Report: TAB Report
Function: Test, Adjust, & Balance
Date: 12/12/2025
Completed By: National TAB

PROJECT
02-02-26 QT #1176 CAYCE, SC

Project: 02-02-26 QT #1176 CAYCE, SC

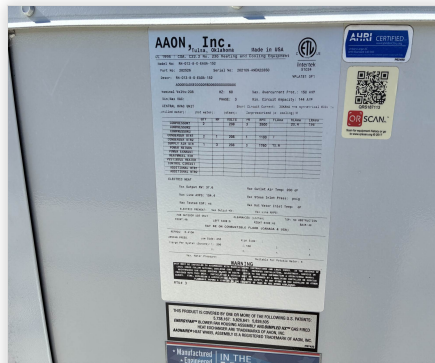
Issue Name : RTU-3 Economizer Actuator Malfunction
Description : The actuator for the economizer stopped responding to commands from the store computer when setting the outside air when the hood is off. The outside air was set manually.
Created By : National TAB **Assigned To :** National TAB - Dan Hertenstein
Status : Open
Priority : Urgent **Asset Tag :**
Originated Date : 02/03/2026 - Alex Bauer - National TAB

Asset: RT-3

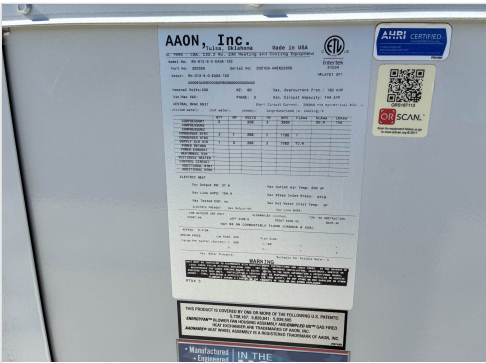
Notes:
See issues list.
